SUBJECT: Preliminary Subdivision Plan: Lake Christine Subdivision
Single Family Residential Subdivision– Parcel #3004050

PC Case No: 2016-03

SUBJECT: Subdivision Review for Lake Christine
Proposed 11 sublot subdivision at 7738 Darrow Road
Preliminary Plan and Tree Clearing Request

Date: January 8, 2016
To: Greg Hannan, Hudson Community Development
From: Bradley S. Kosco, P.E., P.S., Hudson Assistant City Engineer
Re: Lake Christine Preliminary Plan Review

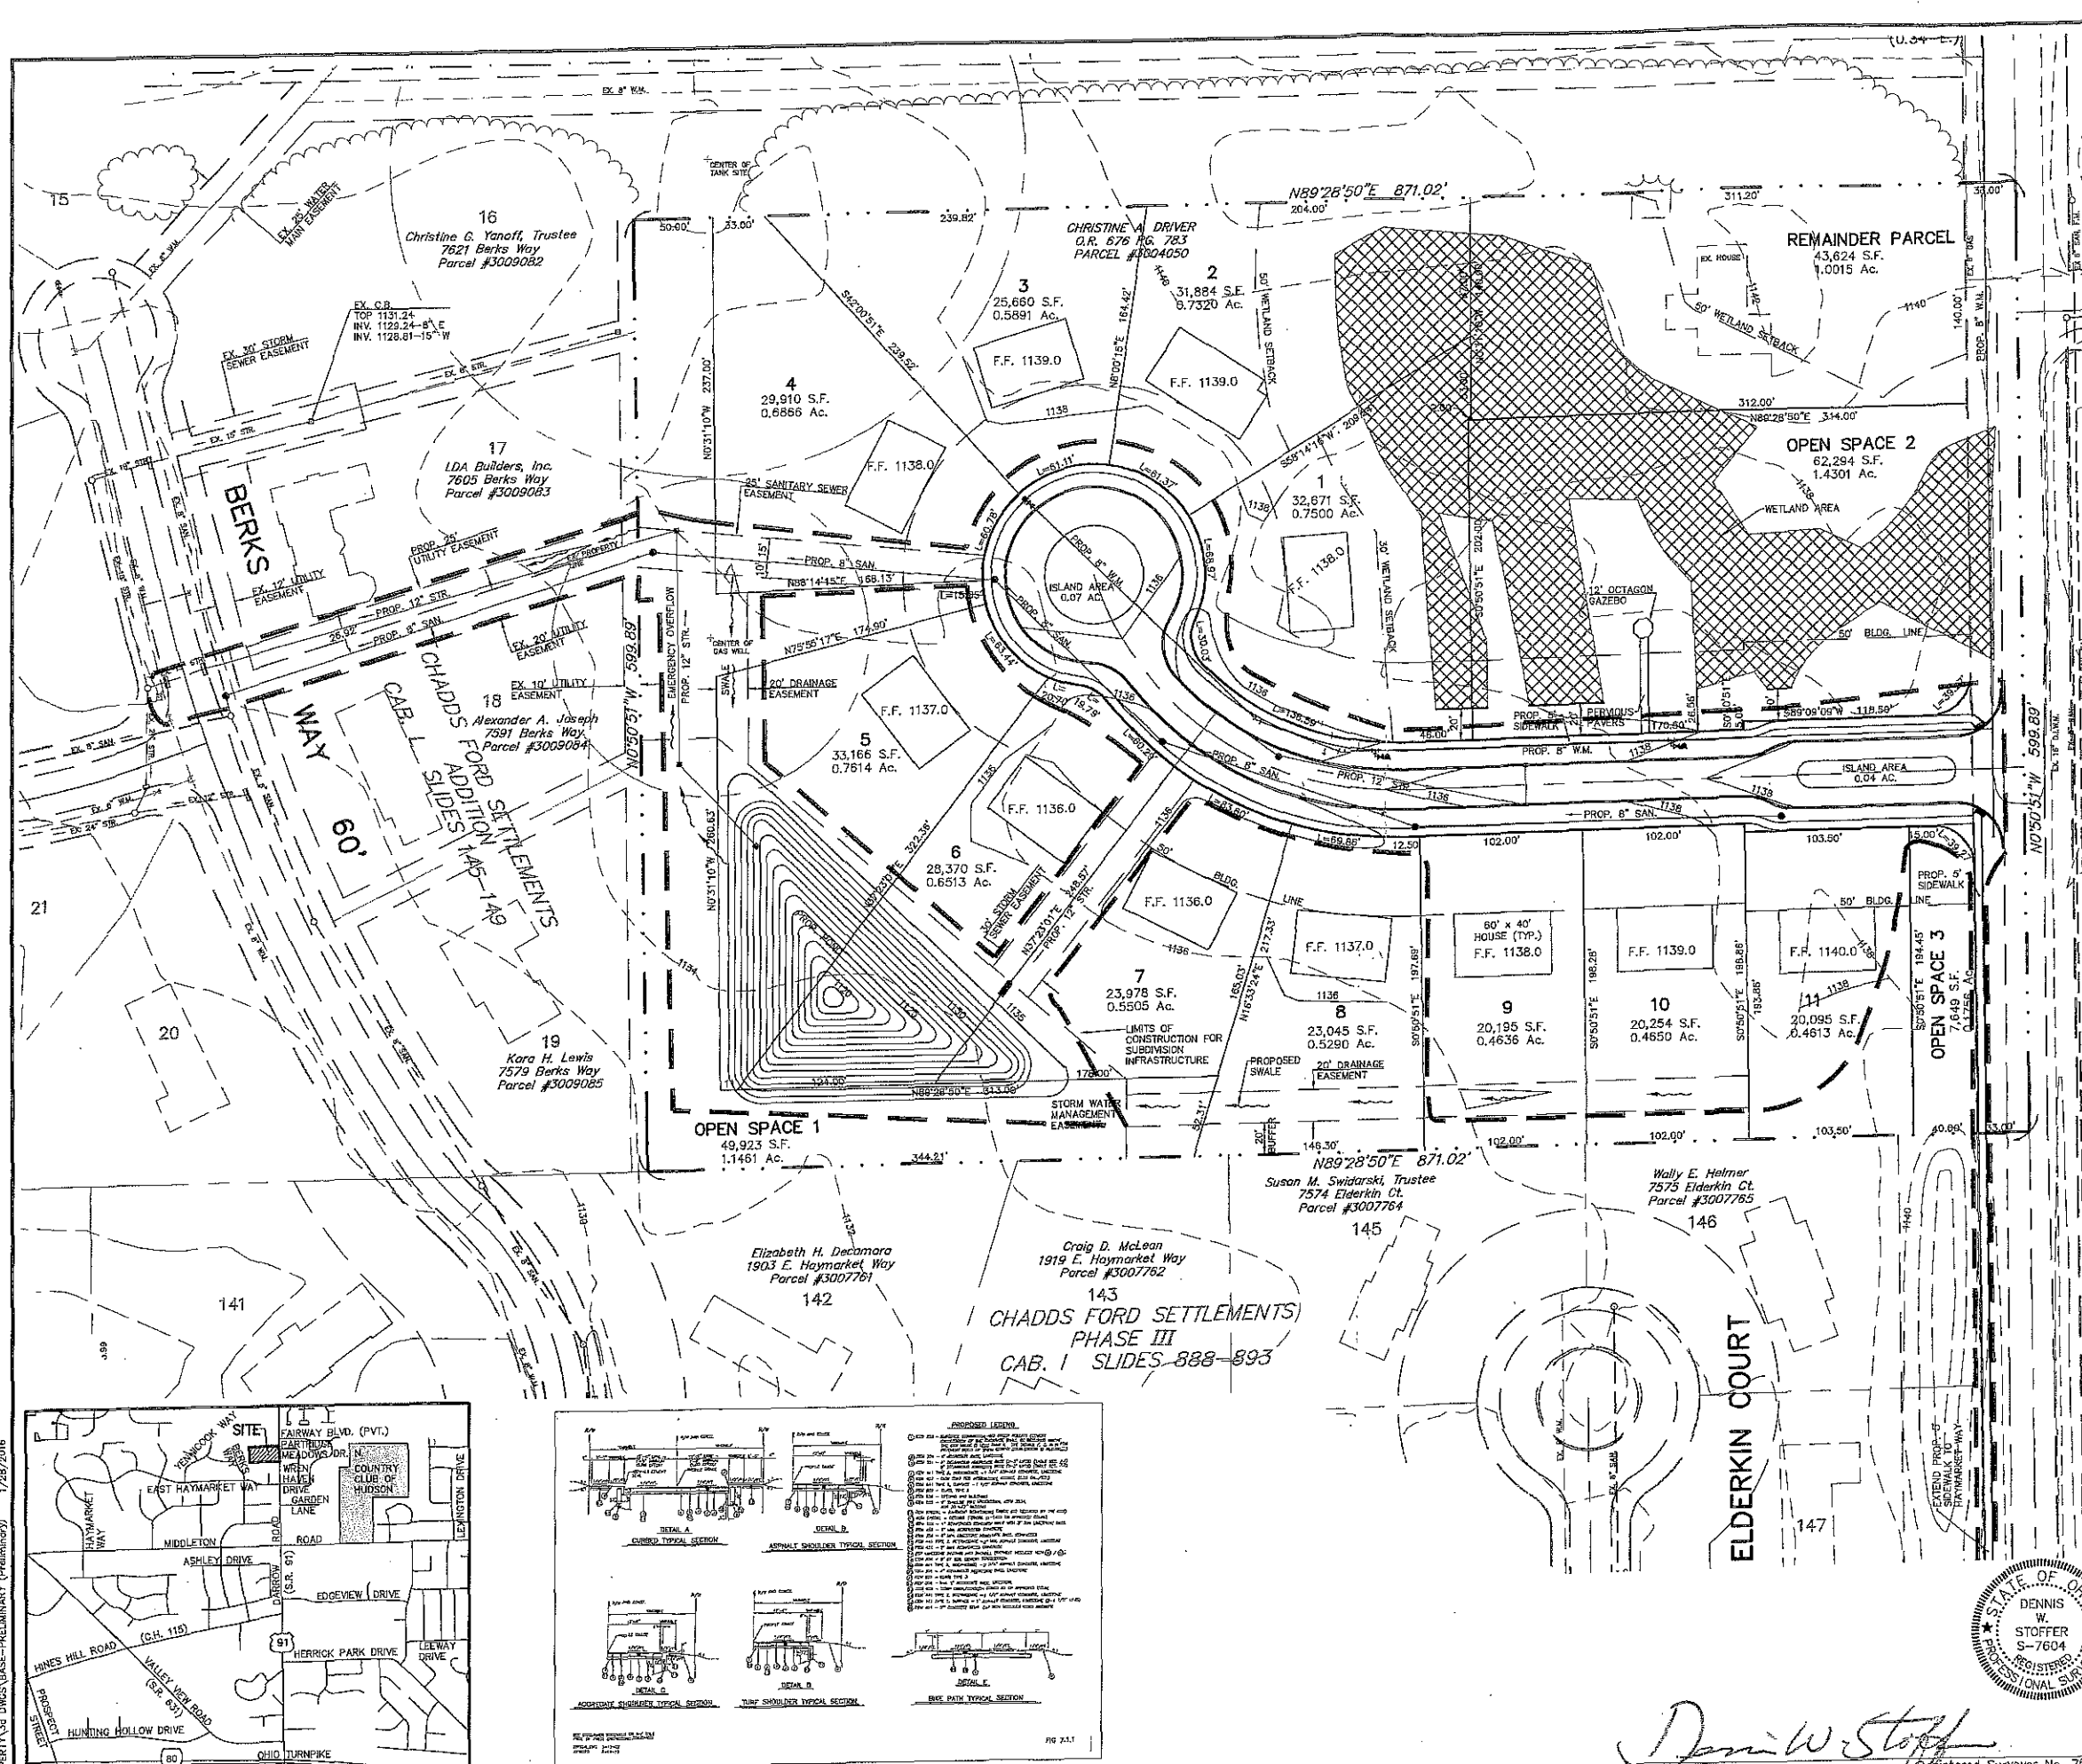
The site is additionally required to provide 25% of the gross land area as private open space. Staff recommends the limits of disturbance adjacent to the stormwater management basin within open space parcel #1 be revised to preserve the existing

Pedestrian and Bicycle Paths - Sidewalks have been appropriately depicted on both sides of the new street. The plan proposes the sidewalk along Darrow Road from the proposed street south to Haymarket Way rather than along the full parcel frontage due to the presence of wetlands north of the proposed street and the desirability to provide a

8. Oil/Gas Exploration: The development contains an existing gas well and tank battery located along the western portion of the site. No structure suitable for occupancy shall be erected within 100 feet of any unplugged oil and gas well head. If the well has been plugged or abandoned a 25 ft setback shall apply. Tank batteries require a 200 ft setback. The plans have labeled the appropriate installations and their applicable setbacks.

Approve the application for Preliminary Subdivision Plan and Tree Clearing approval for Case No. 2016-03 for the Lake Christine Subdivision according to plans dated as received January 29, 2016 with the condition that the applicant must address the following:

Preliminary Plan For
LAKE CHRISTINE
PART OF ORIGINAL LOT 6-FORMERLY HUDSON TOWNSHIP
CITY OF HUDSON
COUNTY OF SUMMIT
STATE OF OHIO

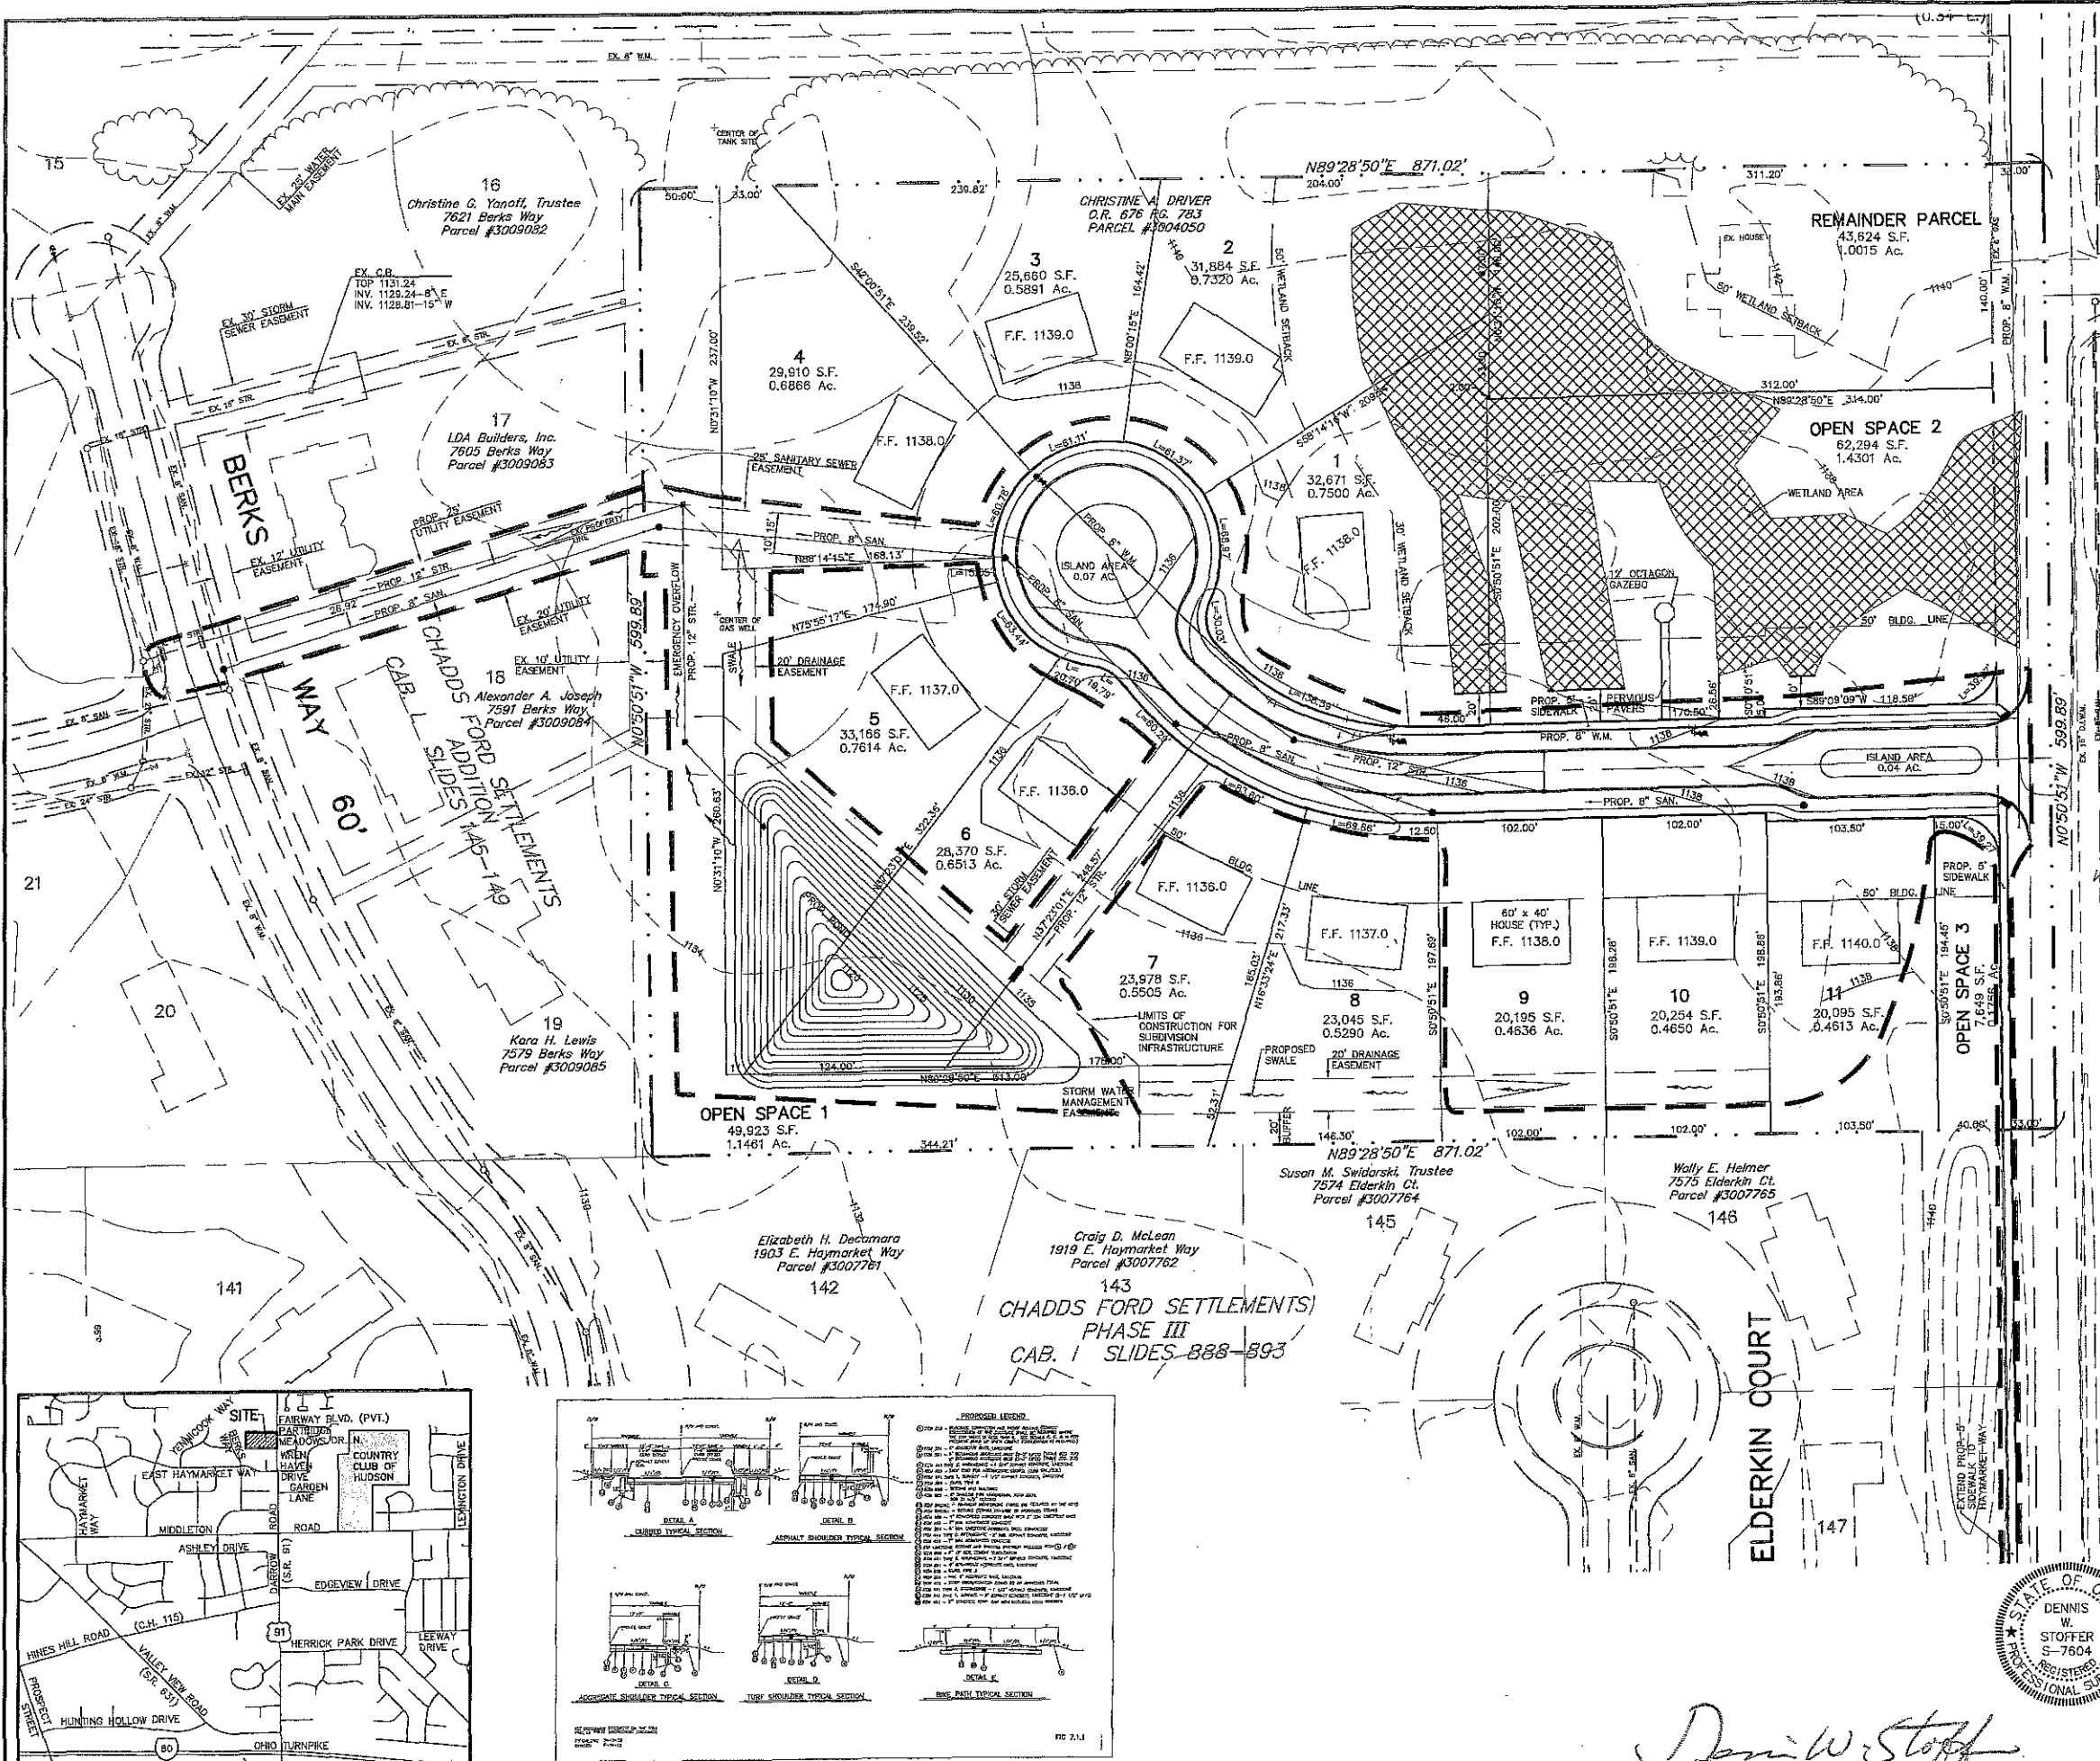
4. The site distance at the intersection of the proposed roadway and Darrow Road shall be evaluated.
5. The roadway appears to be planned as a public Right-of-Way. If so, the typical section shall follow the City of Hudson Engineering Standard Drawing for the roadway (Fig. 7.1.1 attached).

6. Please verify what the circled numbers on the plan indicate.
7. Collect rear lot runoff from lots 4-11 via a swale or other approved system and send to proposed storm water pond.

8. Where is the emergency overflow and 100-year flood path from the proposed storm water pond? Plans shall show applicable details and calculations will be required to carry the design flows.
